Title of Change:	Removal of white marking at bottom of QSB363 T-3/4 package.
Effective date:	10 Oct 2023
Contact information:	Contact your local onsemi Sales Office or Esther.Lau@onsemi.com
Type of notification:	This Product Bulletin is for notification purposes only. onsemi will proceed with implementation of this change upon publication of this Product Bulletin.
Change Category:	Removal of white marking at bottom package.
Change Sub-Category(s):	Removal of white marking at bottom package.

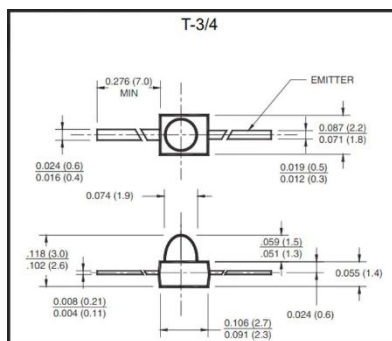
This Product Bulletin documents the removal of the white marking at emitter side at the bottom of QSB363 T-3/4 package. Pin orientation is already indicated in the datasheet.
